PLANNING APPLICATION NUMBER: P12/1447/C7

Type of approval sought	Discharge of condition
Ward	Cradley and Wollescote
Applicant	Wendy Griffin, Nicol Thomas Ltd.
Location	SITE OF FORMER CRADLEY HIGH SCHOOL, HOMER HILL ROAD, CRADLEY, HALESOWEN, B63 2UP
Proposal	DISCHARGE OF CONDITION A32 (STREET LIGHTING DETAIL)
Recommendation Summary	THAT THE DIRECTOR ENVIRONMENT, ECONOMY AND HOUSING BE GIVEN DELEGATED POWERS TO DETERMINE THE DISCHARGE OF CONDITION APPLICATION, SUBJECT TO THE FORMAL SUPPORT OF THE GROUP ENGINEER.

Project: **Homer Hill extra care development**

Title: **Street lighting layout**

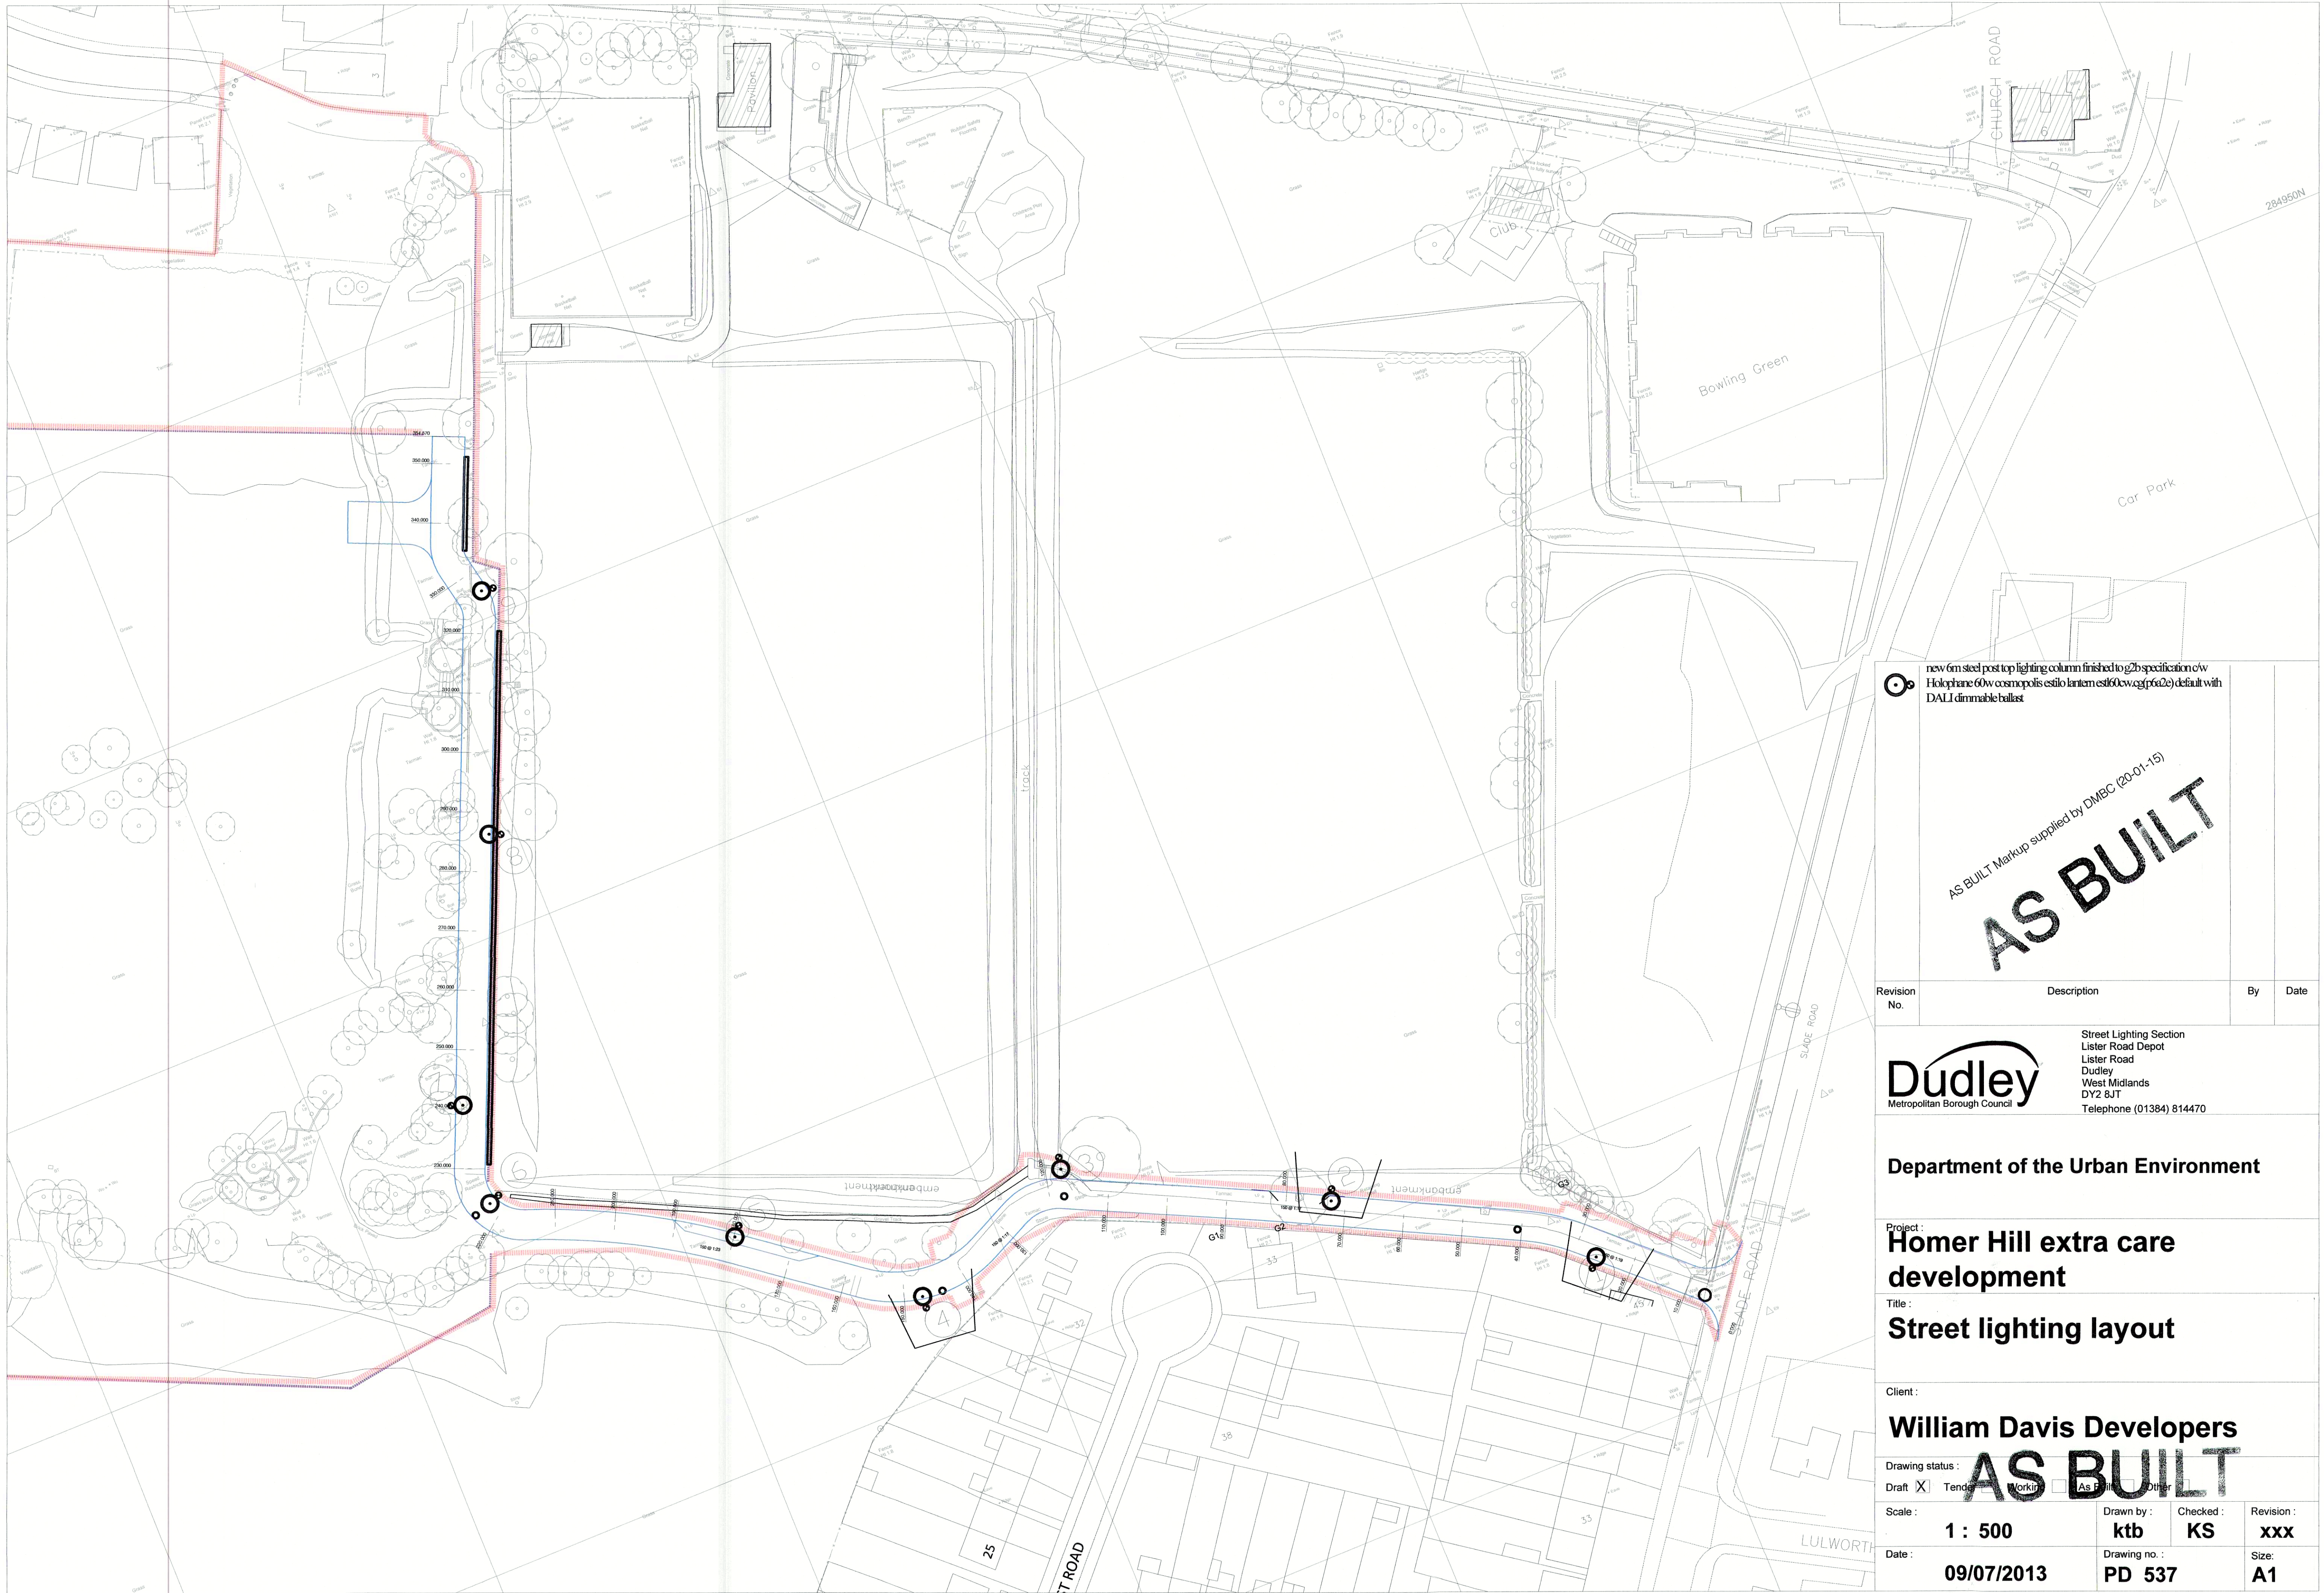
- 18 The street lighting which is already in place is located along the recently improved access road to the site. There have been concerns from a number of neighbours to West Road regarding the impact the lighting is having on their amenity, with columns 1, 2 and 4 causing the most significant concerns.

- 20 Additionally the amended plan shows the provision of rear baffles to columns No. 1 and 4, and forward baffle to No. 2. These baffles are understood to be designed specifically for the type of lantern that is being used at the site.

- 23 The plan shows that lighting levels to adjoining houses notably Nos. 30, 32 and 33 West Road would be less than 2 lux. This level is what the Council tries to achieve with its own schemes and is normally considered to be acceptable level from an amenity point of view. However, this plan needs to be formally considered by the Group Engineer to ensure these levels can be achieved.

- 24 With regard to No. 45, the levels are higher than 2 lux, but the lighting plot does not take into account the house or the existing hedge which implies the levels would much reduced by the shadowing effects these would induce.

- 25 It is noted that concerns have been raised regarding the potential for light pollution to the wider area, and the impact it may have on wildlife and the night sky. The lighting plan again demonstrates that light levels will concentrated principally onto the road, rather than spilling out onto the park.

- 27 At the time of writing the Group Engineer (Highways) has informally indicated that the revised details are acceptable and should not have an adverse impact on amenity, but is of the view that the works need to be inspected on site before formalising his view. As such the Director of Environment, Economy and Housing is requesting delegated powers to determine this discharge of condition application once the Group Engineer (Highways) has formally agreed that the revised details are acceptable.

- 29 Following the receipt of the additional information, the revised details are acceptable and are not considered to have an adverse impact on amenity. Consideration has been given to the Black Country Core Strategy and saved policies DD4 and EP6 of the Dudley Unitary Development Plan.
